**RE: Windler – Neighborhood P (PA-25) Traffic Conformance
 FHU Project No. 122259-01**

Re: Coordination of utilities within the alleys at City of Aurora

From: Alina Randall
Sent: Monday, July 31, 2023 3:22 PM
To: Cox, Jacob; Adam, Vern; Dancy, Cesarina
Cc: Chris Fellows; Tom Odle; Karl Knapp; Ballard, Casey
Subject: Utility Easement at Alleys
Attachments: 2023.07.31 Alley Exhibits with Utility Easemens.pdf

1. PLAN VIEW OF 23FT WIDE CONCRETE ALLEY WITH 2 UTILITIES.

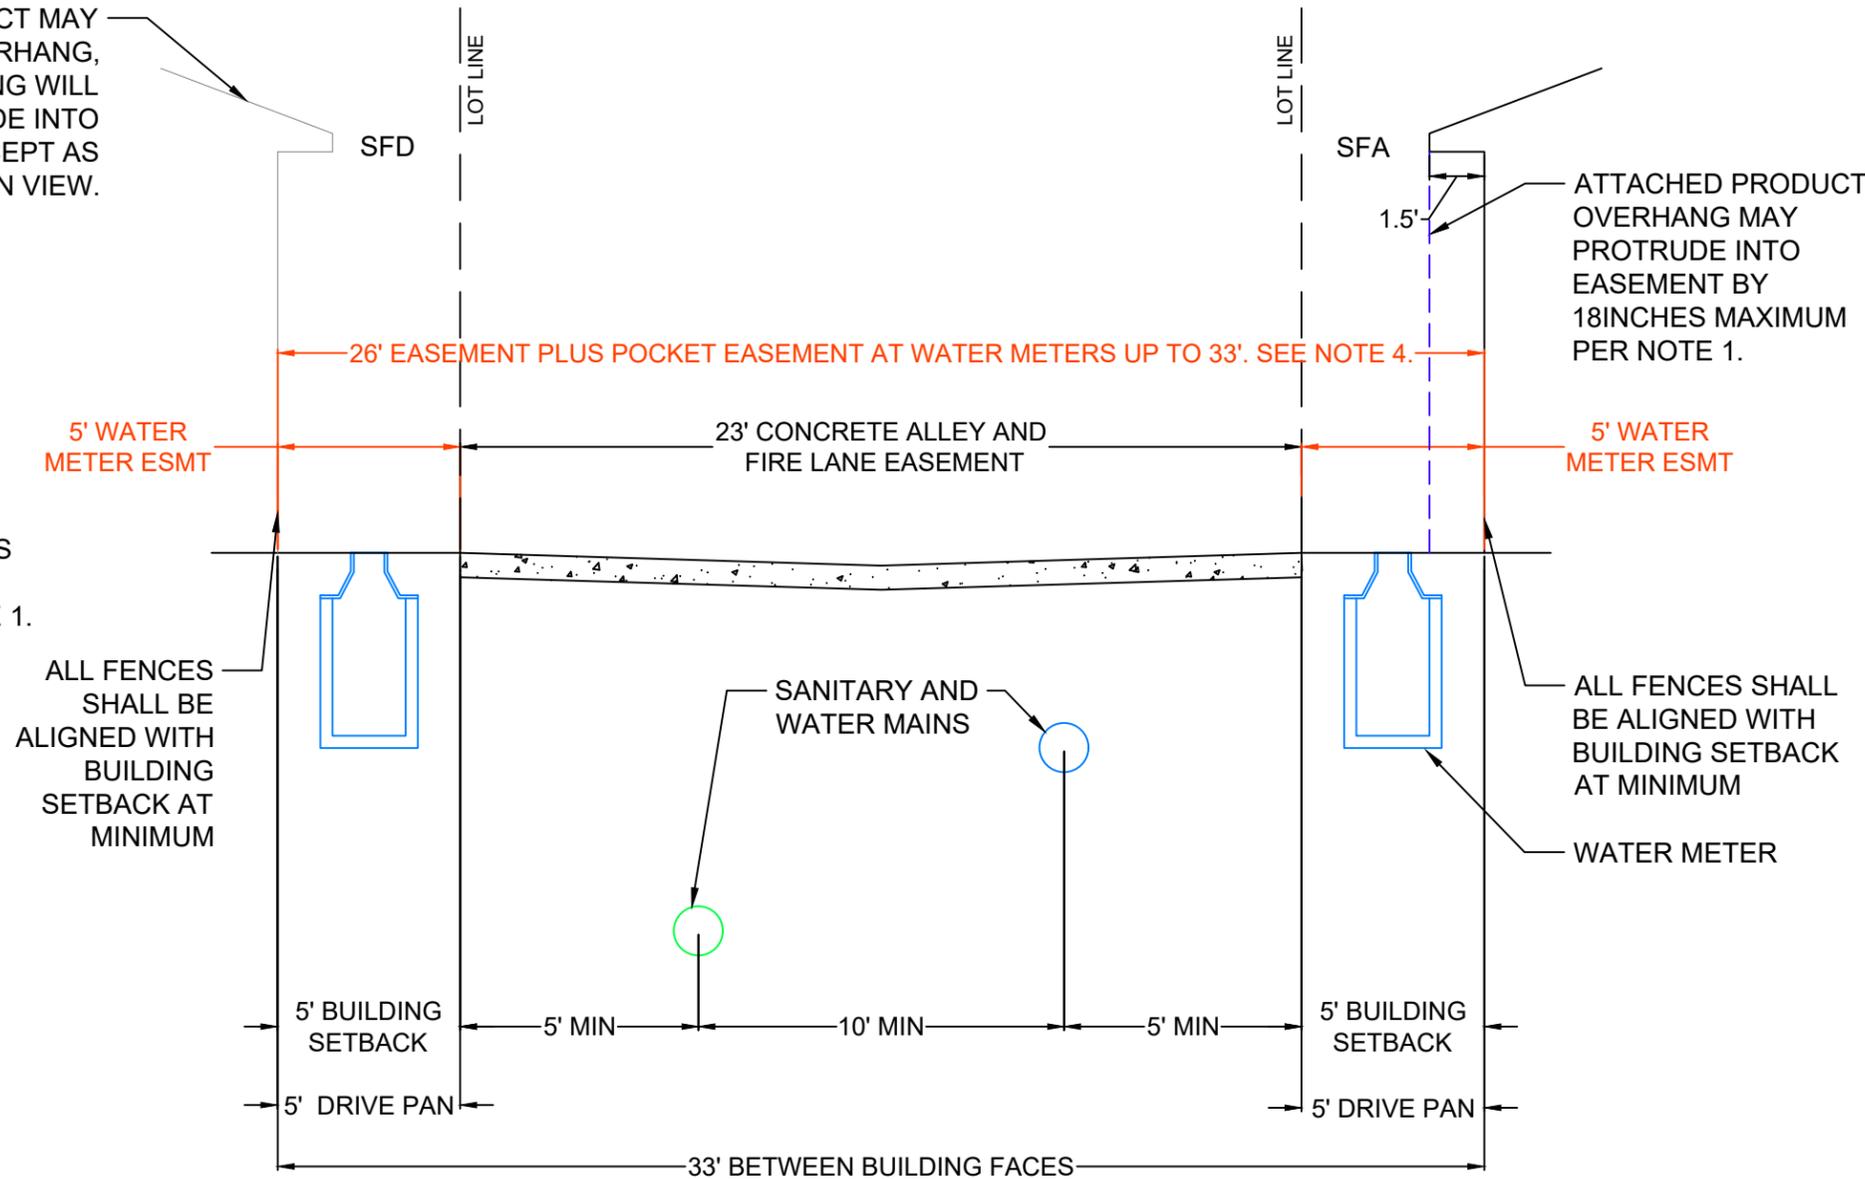
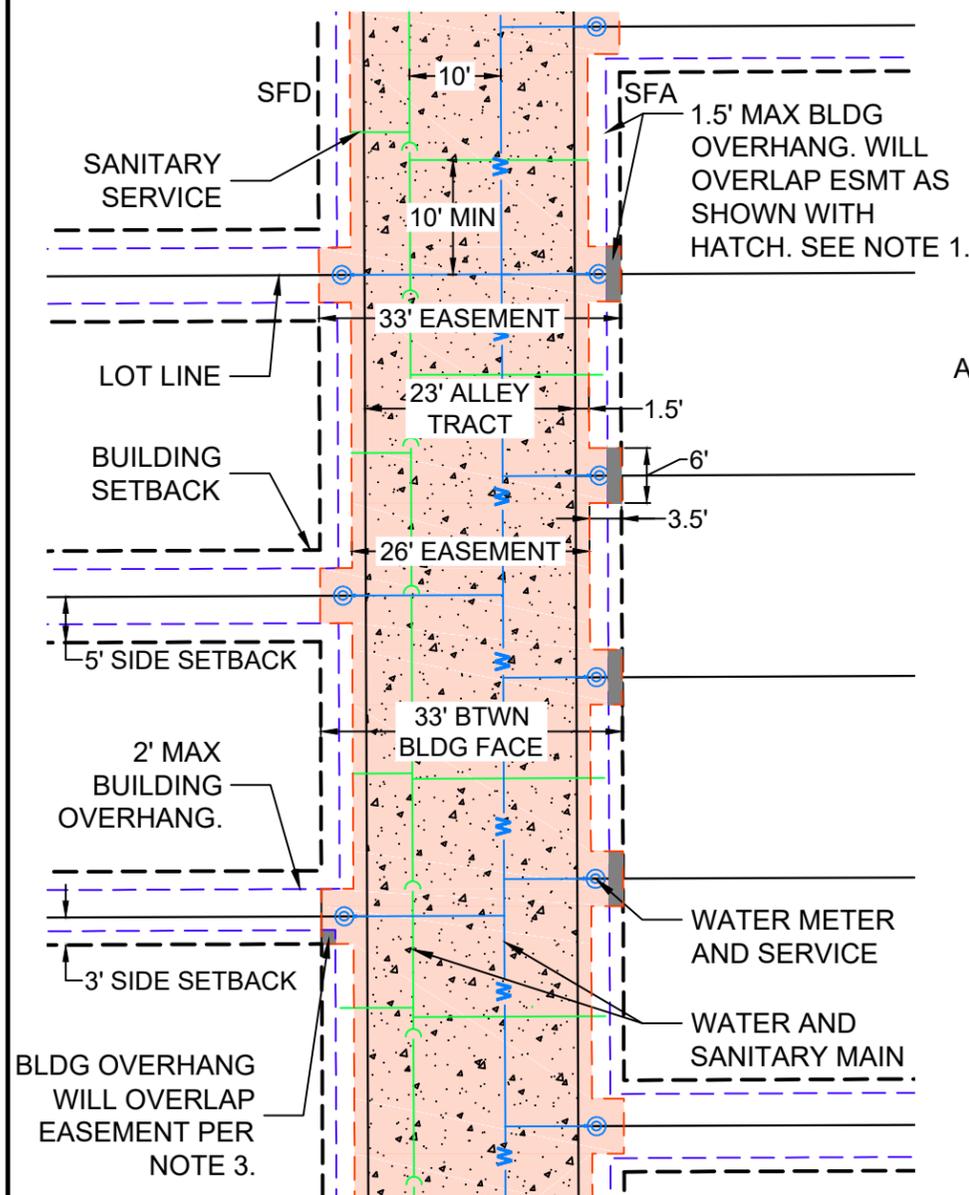
I just spoke with Real Properties Division. They will require that the dedication of the easement reflect the omission of the pocket utility easement where the encroachment occurs. I was mistaken that the encroachment can occur without the benefit of this deletion. I would also ask a note is provided on the site plan that the lot owner recognizes our ability to enter the space to operate and maintain the space deleted.

14A. Include the typical easement information to ensure there are no structural encroachments. This includes foundation, roof overhangs, 2nd floor bump outs, etc.

16A. See the Advisory Comments on the first page of the plat. Check the names of the easements on both documents. Confirm these names with Aurora Water and Fire/Life Safety Departments. There is a statement on the Site Plan saying that the eaves may encroach into the Water easements for the Water meters. This is not allowed (refer to the Site Plan checklist and the Subdivision Plat Checklist.)

1. ATTACHED PRODUCT CAN HAVE 18 INCH OVERHANG PROTRUDE INTO VERTICAL EXTENSION OF EASEMENT. OVERHANG MAY NOT BE LESS THAN 12FT ABOVE GROUND LEVEL AT POINT OF PROTRUSION.
2. DETACHED PRODUCT CAN HAVE 2 FOOT OVERHANG PROVIDED IT DOES NOT PROTRUDE INTO VERTICAL EXTENSION OF EASEMENT. SEE NOTE 3.
3. FOR DETACHED PRODUCT, IF SIDE YARD SETBACK IS REDUCED TO 3FT (MAY REQUIRE FIRE RATED WALLS), THEN OVERHANG MAY PROTRUDE UP TO 18 INCHES INTO THE "POCKET" WATER METER EASEMENT.
4. IF WATER METERS ARE ONLY REQUIRED ON ONE SIDE OF ALLEY, A 3FT MIN EASEMENT WILL BE PROVIDED WITH 5FT POCKETS, SIMILAR TO 20FT ALLEY LAYOUT. THIS WILL PROVIDE A 23FT + 3FT = 26FT EASEMENT MINIMUM.

1. PLAN VIEW OF 20FT WIDE CONCRETE ALLEY WITH WATER MAIN ONLY.

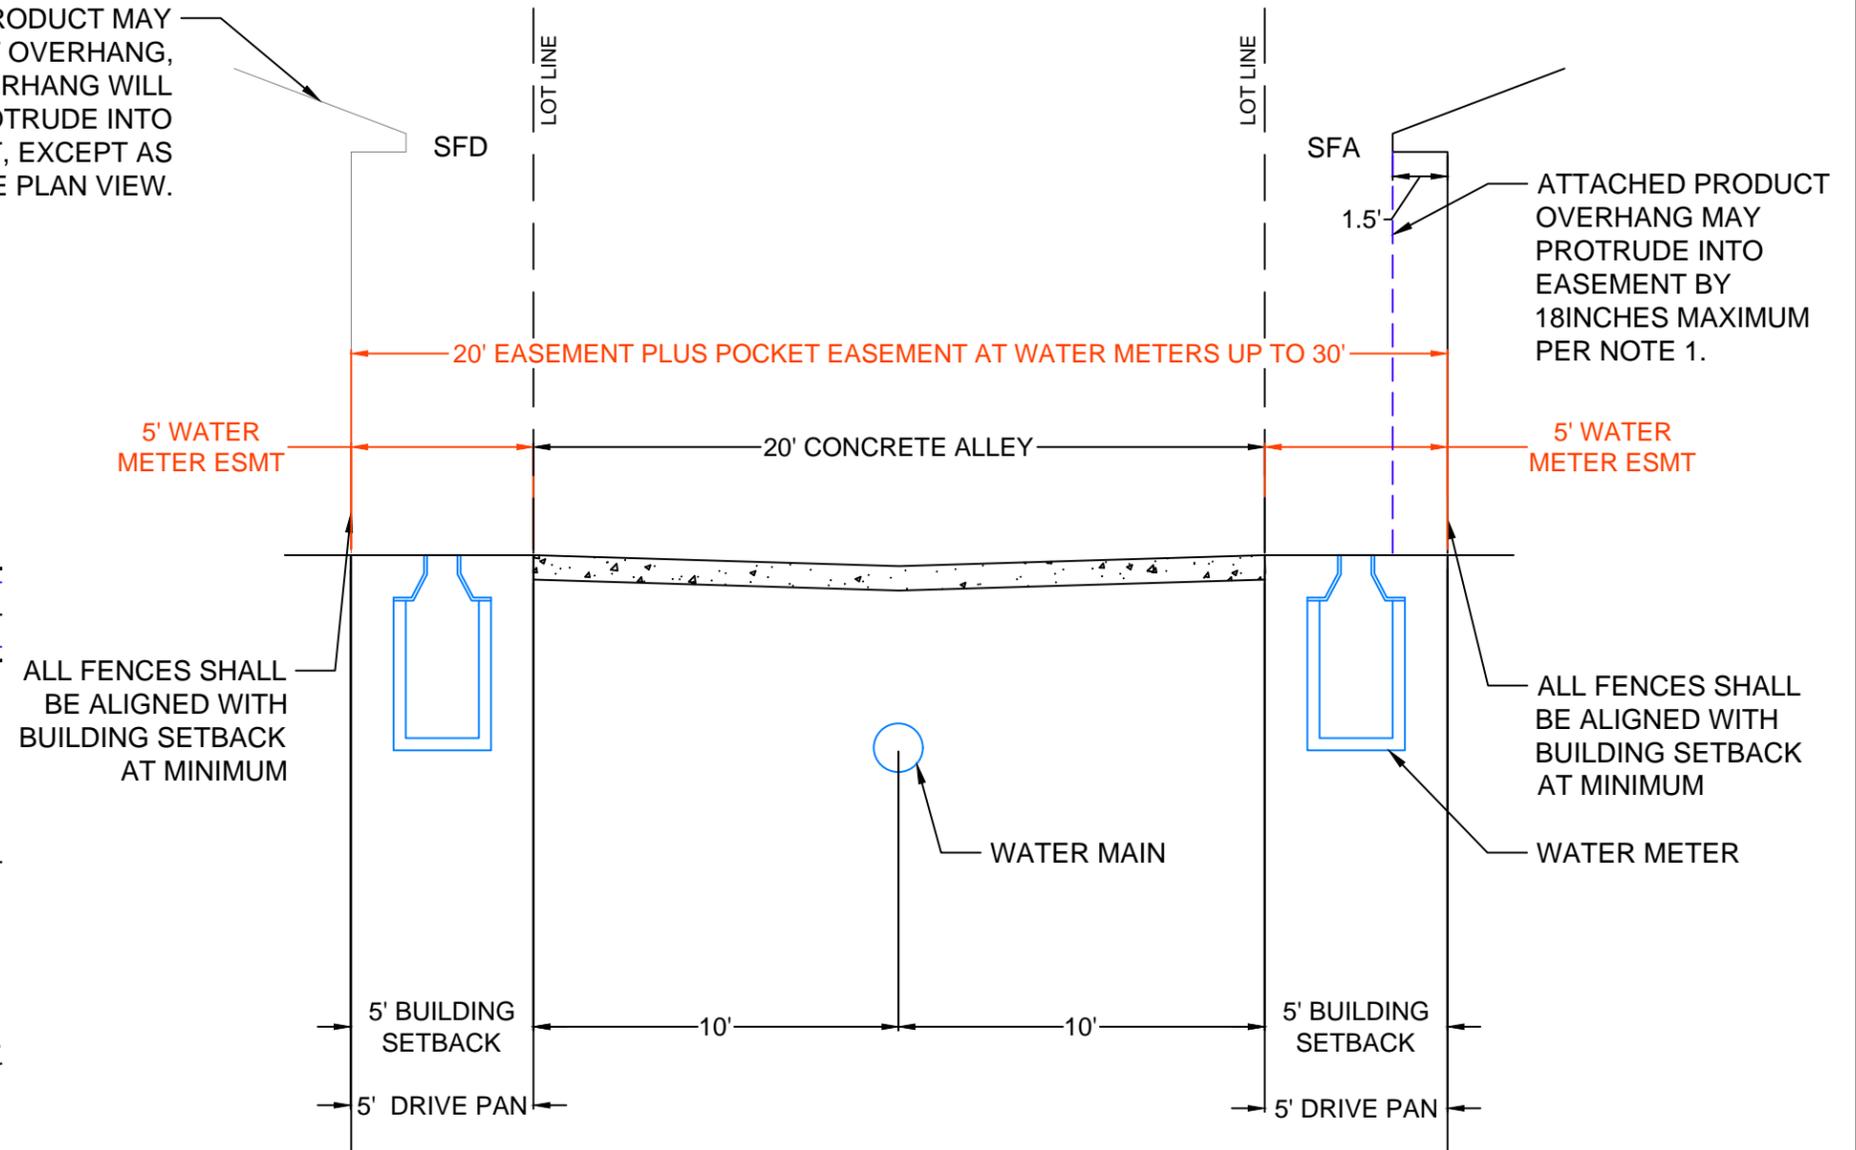
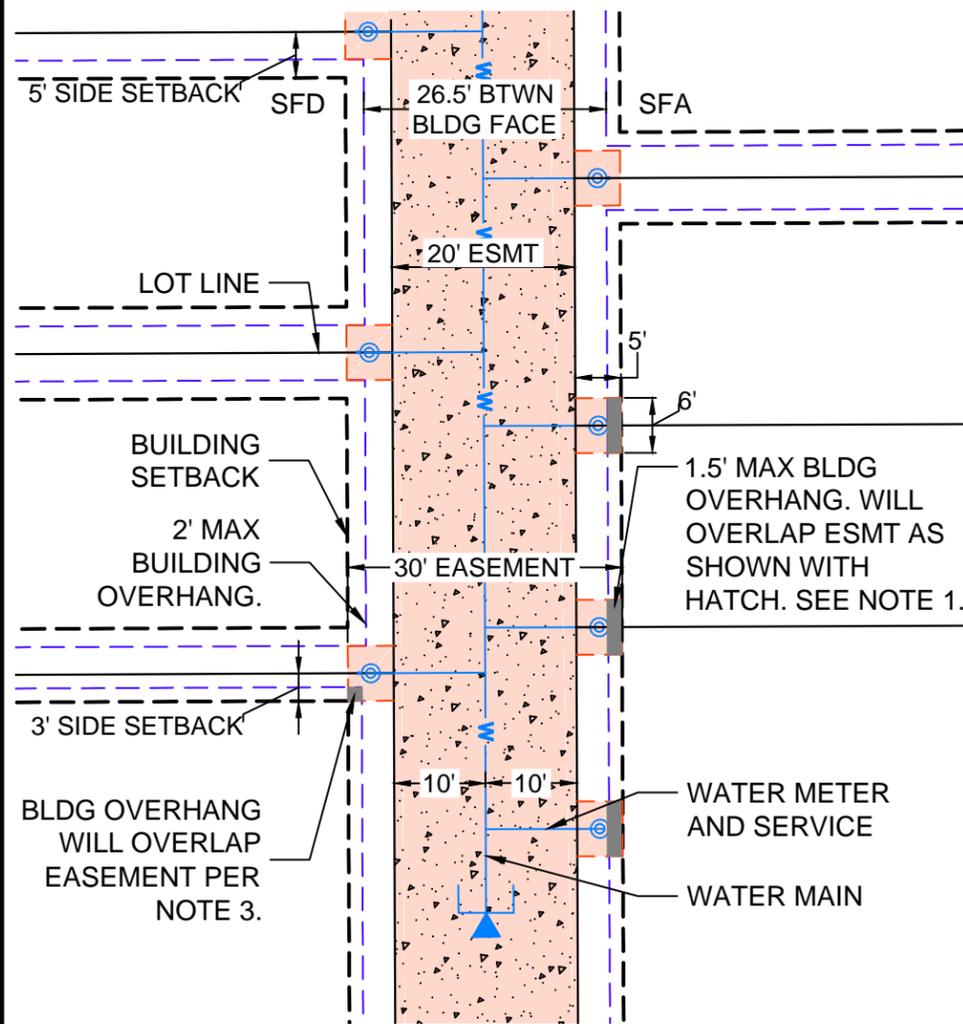
8/02/2023 – Alley exhibits discussed at COA Summit Meeting. Vern commented that his team was not comfortable with a 16ft wide alley with a water main. A 20ft wide alley was preferred.

I have updated sheet 3 of the attached to show a 20ft concrete alley when there is only a watermain installed per your comment a few weeks ago. Please let me know if anything else is needed on this.

8/15/2023 – Westwood updated alley exhibits to show a 20ft wide alley when only a watermain is being installed. These final exhibits are attached here for reference.
